Landscape Review Committee
Community Development Center, 231 NE 5th Street
May 16, 2018
12:00 PM

DATE: May 16, 2018
TO: McMinnville Landscape Review Committee
FROM: Chuck Darnell, Associate Planner
SUBJECT: Agenda Item 4A: L 1-18

An application for a street tree plan and for landscaping of open space tracts within multiple phases of a subdivision (L 1-18) to be reviewed by the Landscape Review Committee.

DECISION, CONDITIONS OF APPROVAL, FINDINGS OF FACT, AND CONCLUSIONARY FINDINGS OF APPROVAL OF THE MCMINNVILLE LANDSCAPE REVIEW COMMITTEE FOR APPROVAL OF A STREET TREE PLAN AND LANDSCAPE PLAN FOR THE BAKER CREEK WEST AND BAKER CREEK EAST SUBDIVISIONS

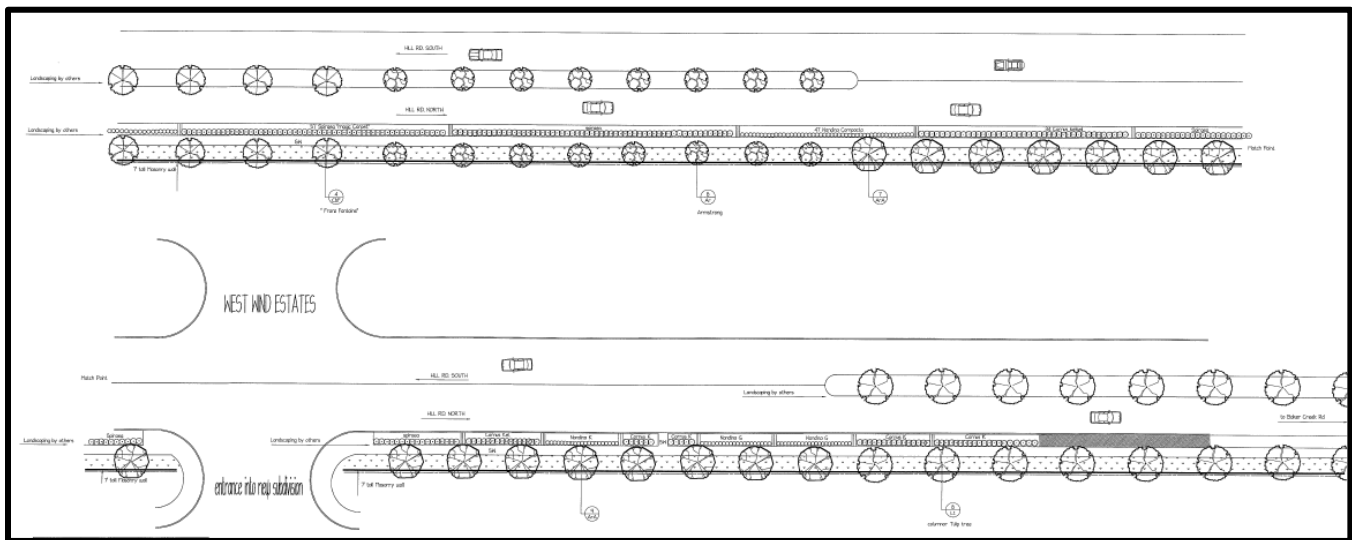
The applicant is proposing to install Red Sunset Red Maple (*Acer rubrum* 'Franksred') trees as the street tree species in the Baker Creek West subdivision. The applicant is also proposing to install Fastigiata Common Hornbeam (*Carpinus betulus* 'Fastigiata') trees as the street tree species in the Baker Creek East subdivision. Both of these tree species are listed on the McMinnville Street Tree list as approved species, and both are considered to be medium sized trees on the McMinnville Street Tree list. The other trees being proposed on the street tree and landscape plan will not be located within public right-of-way, and therefore are not considered street trees. The use of the other tree species will

The applicant was proposing to install a continuous row of arborvitae along the western perimeter of the Baker Creek West subdivision adjacent to Hill Road. However, the approval of the Planned Development (in condition of approval #41) included a requirement that “street tree specifications will be provided by the City of McMinnville for Hill Road and Baker Creek Road”. In place of the proposed arborvitae, the City developed a street tree plan for this portion of the Baker Creek West subdivision adjacent to Hill Road. The plan includes the installation of an alternating variety of Armstrong Red Maple, Autumn Spire Red Maple, Fastigiata Common Hornbeam, and Tulip trees. These tree species were selected to coincide with the street trees that will be installed in the center of Hill Road as part of the reconstruction of that street. Along Baker Creek Road, the City will require that the existing street trees be retained and continuously maintained. A condition of approval has been included to require this street tree plan be followed for the Hill Road frontage, as described in a memorandum to the developer on May 4, 2018. The street tree plan for the area along the Baker Creek West frontage on Hill Road is provided below:

The street tree plan as provided does not identify the size of the proposed trees. A condition of approval is included to specify that the trees be a minimum of two (2) inches in caliper measured at six (6) inches above ground level. The condition of approval also states that all trees shall be healthy grown nursery stock with a single straight trunk, a well developed leader with tops and roots characteristic of the species cultivar or variety.

2. That the tree species approved for the planting strips in the Baker Street West subdivision is Red Sunset Red Maple (*Acer rubrum* 'Franksred'), and that the tree species approved for the planting strips in the Baker Street East subdivision is Fastigiata Common Hornbeam (*Carpinus betulus* 'Fastigiata').

3. That the street trees to be installed in the Hill Road right-of-way space adjacent to the west boundary of the Baker Creek West subdivision be consistent with the street tree plan provided to the applicant and developer in a memorandum on May 4, 2018.

5. That all trees shall be a minimum of two (2) inches in caliper measured at six (6) inches above grade.
6. All trees shall be healthy grown nursery stock with a single straight trunk, a well developed leader with tops and roots characteristic of the species cultivar or variety. All trees must be free of insects, diseases, mechanical injury, and other objectionable features when planted.

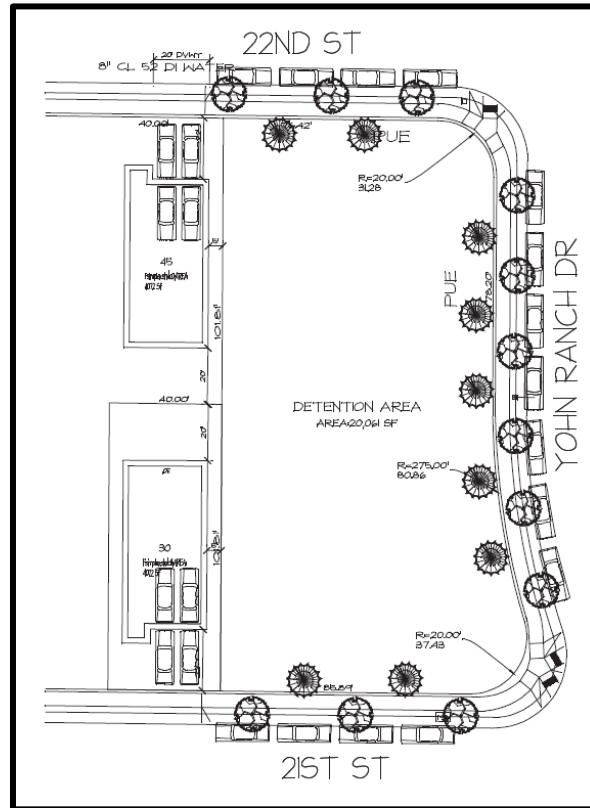
In the detention area in Tract A, the applicant is proposing to plant nine Excelsa Western Red Cedar (*Thuja plicata* ‘Excelsa’) trees along the outer perimeter of the detention area, and then install water quality seed mix within the graded detention area. The applicant provided details for the water quality seed mix being proposed, which includes a mixture of Slough Sedge, Small Fruited Bulrush, Dense Sedge, and Creeping Spikerush.

Open Spaces (Tract B and Tract C):

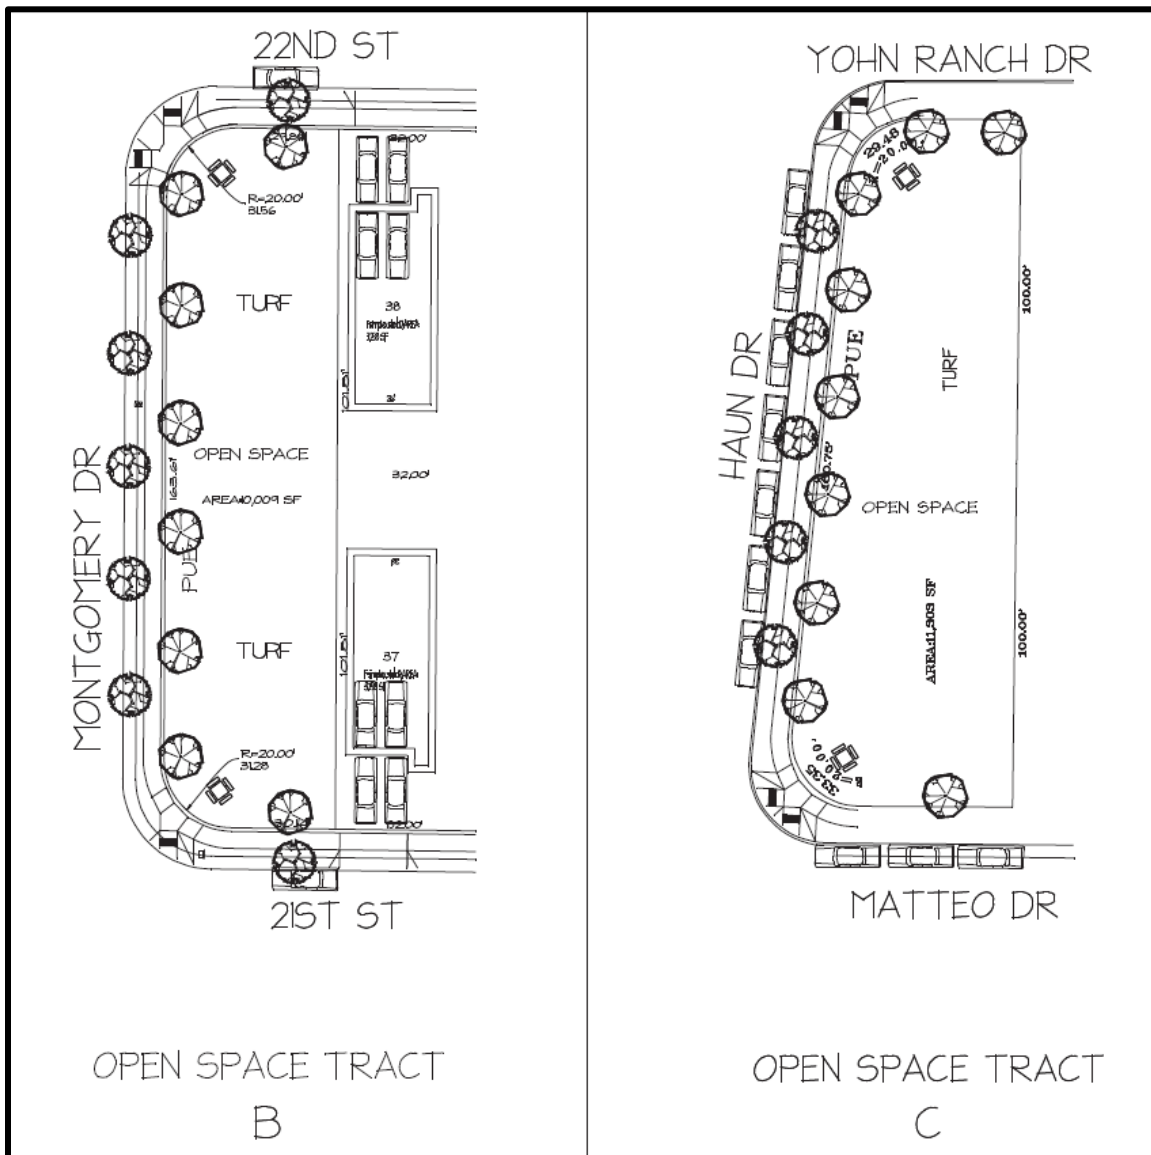
In these open space tracts, the applicant is proposing to install Katsura (*Cercidiphyllum japonicum*) trees along the outer perimeter of the open space tracts, and then to install turf grass throughout the remainder of the tract. Staff is supportive of the use of turf grass in a majority of the open space area. These open space areas were required during the Planned Development to provide for usable open space for residents of the subdivision, based on the smaller lots and yards that were allowed to be constructed. The applicant is also proposing to install picnic tables at the corners of each of the open space tracts to provide seating for users of the open spaces. These improvements were also required by the Planned Development approval (condition of approval #4) subject to the Planning Director’s approval, and the Planning Director has approved the type and placement of picnic tables as shown on the landscape plan.

Open Space (Tract D):

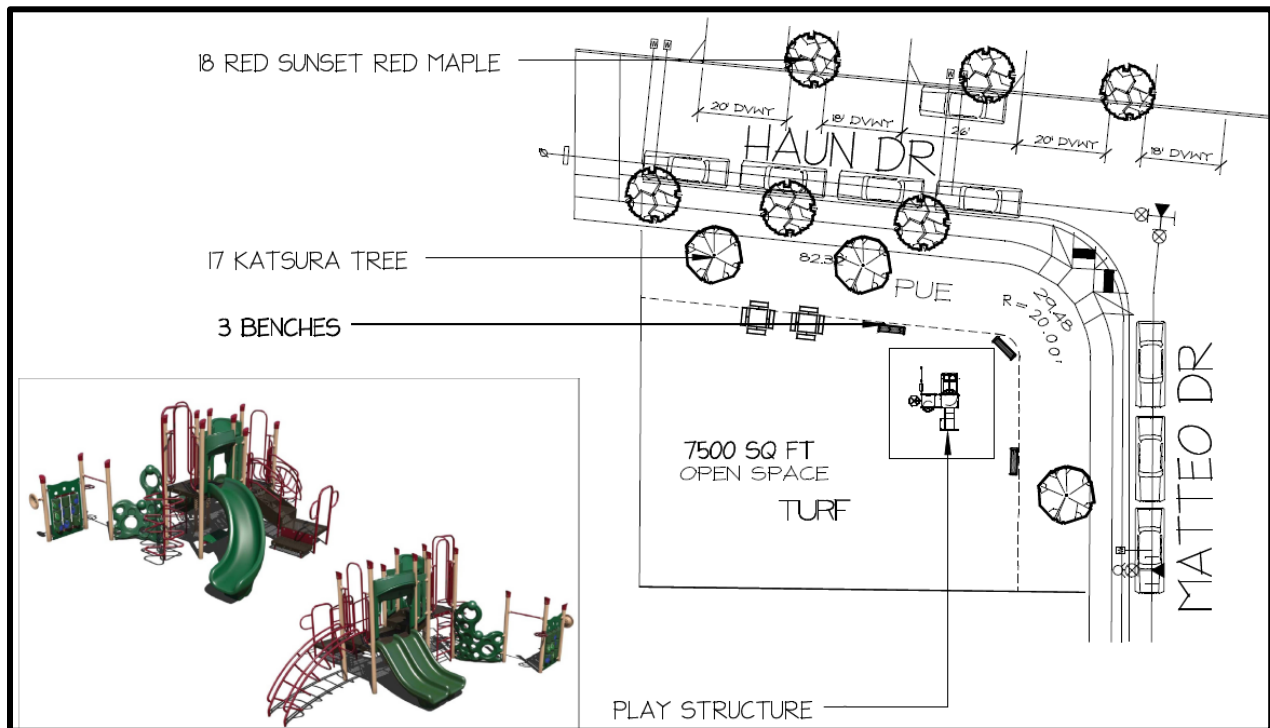
Similar to the other Baker Creek West open space tracts, the applicant is proposing to install Katsura (*Cercidiphyllum japonicum*) trees along the outer perimeter of Tract D, and then to install turf grass throughout the majority of the open space tract. However, the Planned Development approval (condition of approval #4) required that play equipment be provided in this open space tract. The applicant is also proposing to install picnic tables on the north side of the open space tract, play equipment internally oriented near the northeast corner of the open space tract, and then three benches surrounding the play equipment space. All of these improvements will be within the site, setback at least 10 feet from the property lines, to provide for some buffering between the usable features and the street. The applicant is proposing to finish the play equipment area with wood chips. These improvements were required by the Planned Development approval (condition of approval #4) subject to the Planning Director’s approval, and the Planning Director has approved the type and placement of picnic tables as shown on the landscape plan.

Pedestrian Accessways (on Lot 16 and Multifamily Lot):

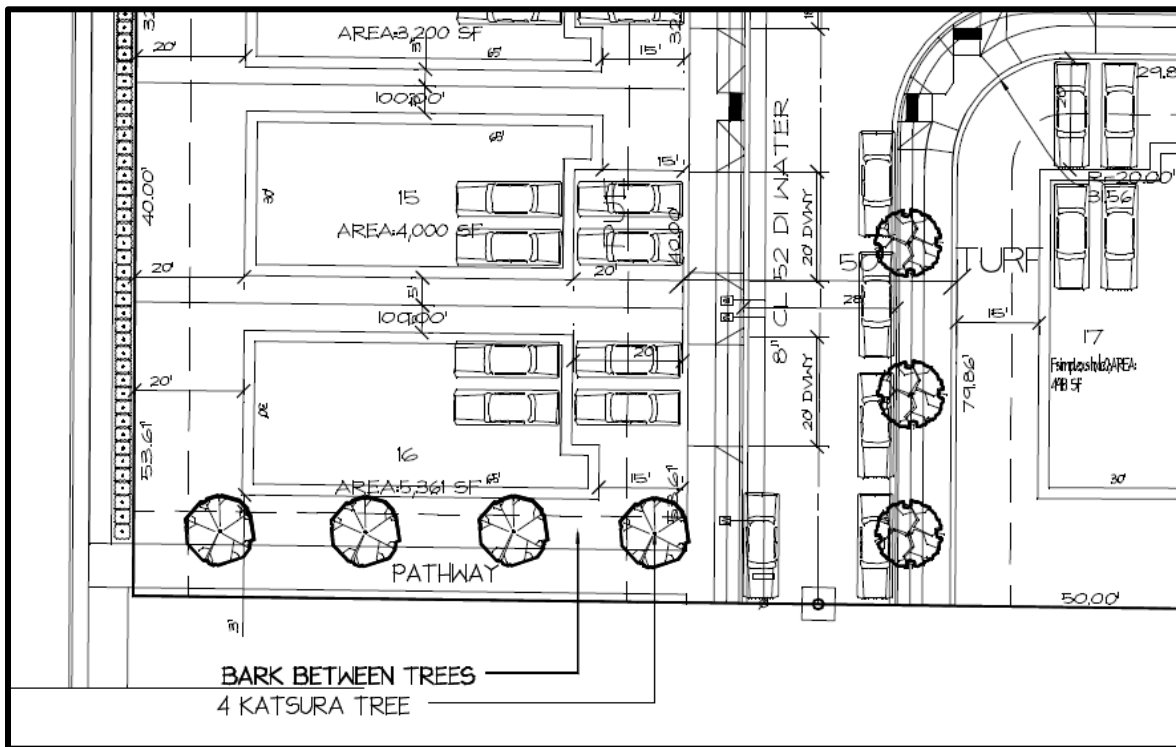
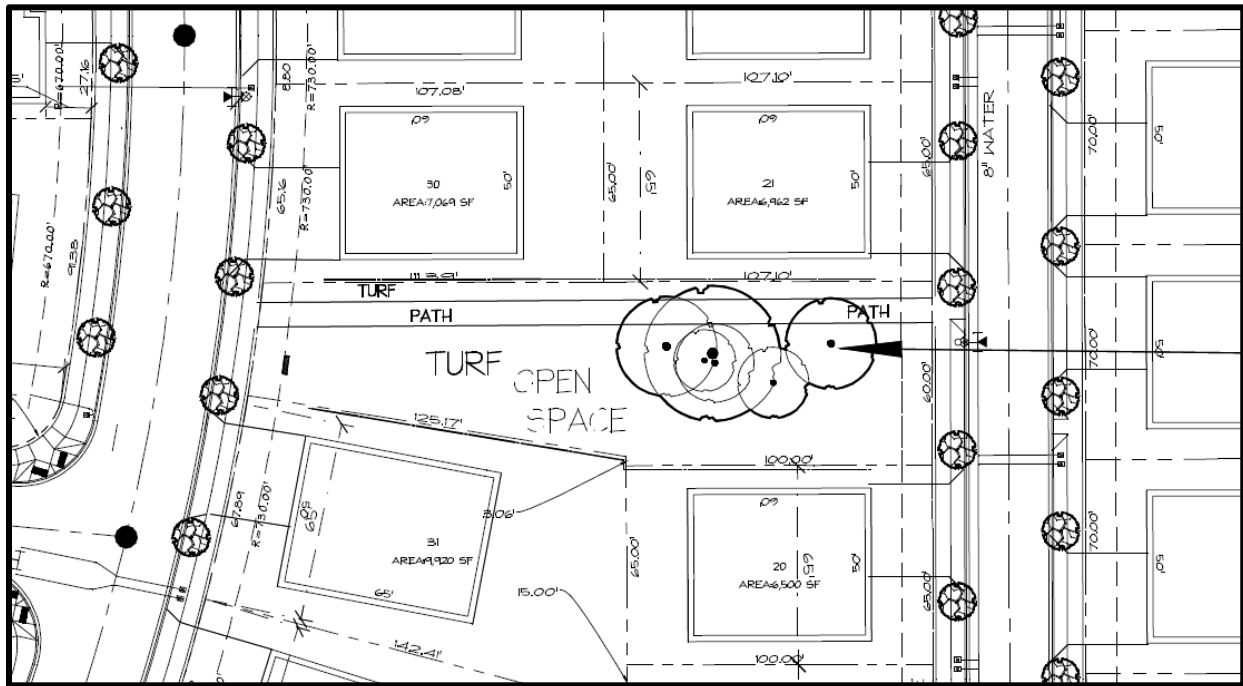
The pedestrian accessways were required by the Planned Development approval (condition of approval #4, #37, and #39) to provide additional pedestrian accessibility within the subdivision and to also connect to other areas outside of the subdivision. The accessway on Lot 16 will provide a pedestrian connection between Montgomery Drive and Hill Road. The applicant is proposing to include a 10 foot wide pathway, and then a planter strip between the pathway and the buildable area of Lot 16. The applicant is proposing to improve the planter strip with four evenly spaced Katsura trees and bark dust between the trees.

The other pedestrian accessway will be located on the multifamily site, providing a pedestrian connection between Haun Drive and Baker Creek Road. The landscaping for this pedestrian connection was not shown on the submitted street tree and landscape plan, and therefore will be deferred to and reviewed during the review of the landscape plan for the multifamily site.

Open Space and Detention Area (Tract B):

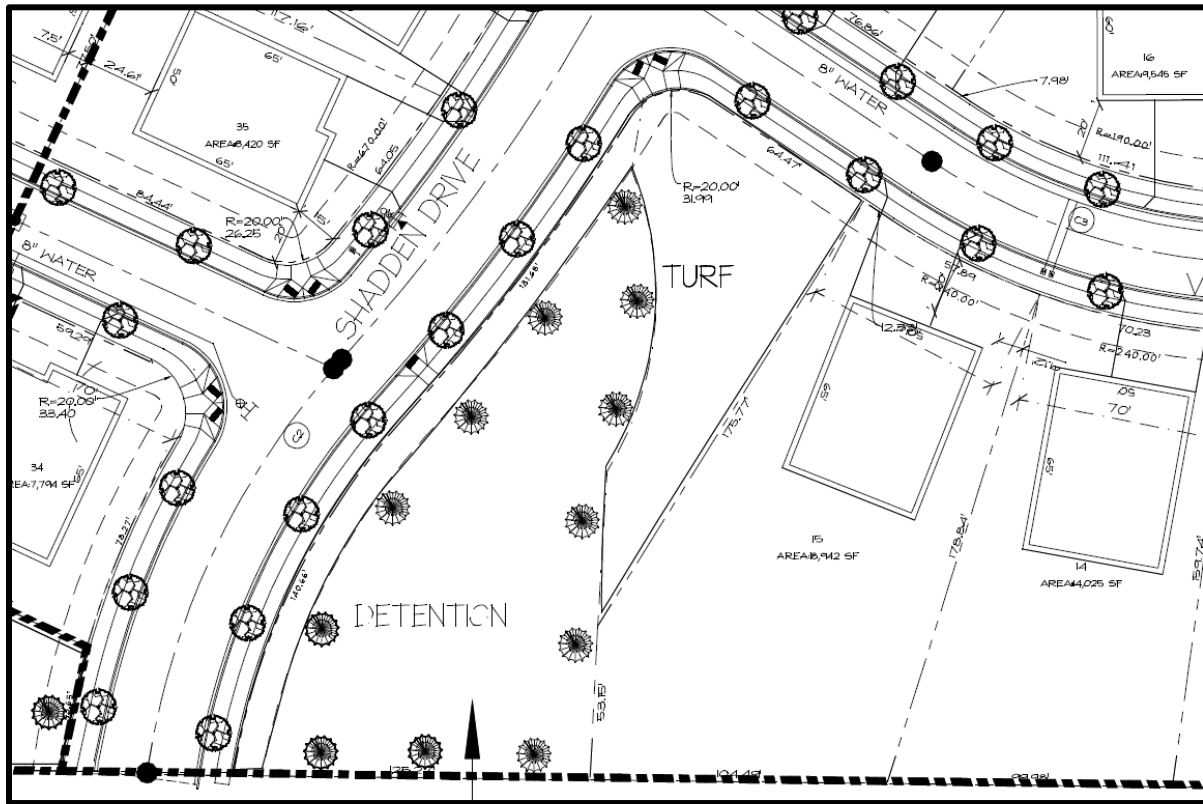
This open space tract will include some level area, proposed by the applicant to be just turf, and also a detention area. The applicant is proposing a similar treatment in this detention area as proposed in Baker Creek West, with Excelsa Western Red Cedar (*Thuja plicata* 'Excelsa') trees along the outer perimeter of the detention area and water quality seed mix within the graded detention area.

Detention Area and Pedestrian Accessway (Tract C):

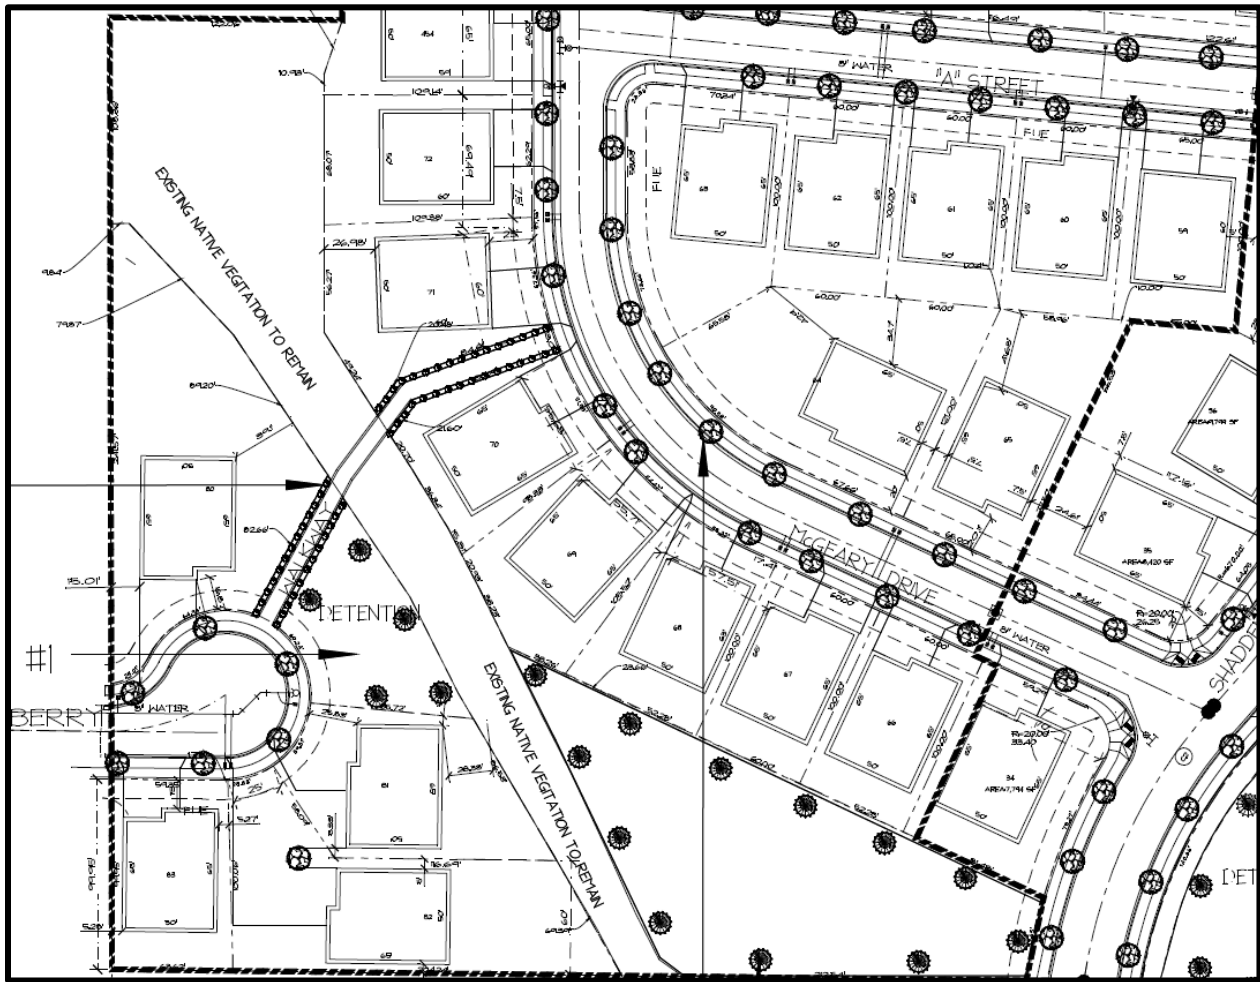
This larger detention area, which includes a detention pond on the southeast corner of the tract near Shadden Drive and a detention pond on the east end of the Snowberry Street cul-de-sac, will primarily be maintained with the existing native vegetation. The detention pond areas will be treated again with Excelsa Western Red Cedar (*Thuja plicata* 'Excelsa') trees along the outer perimeter of the detention areas and water quality seed mix within the graded detention areas. The tract also includes a required pedestrian accessway between Snowberry Street and McGeary Drive. The applicant is proposing a 10 foot pathway through the tract with a slightly narrower bridge over the existing natural drainageway. Along the accessway, the applicant is proposing to install continuous rows of Nootka Rose (*Rosa nutkana*) on each side of the accessway.
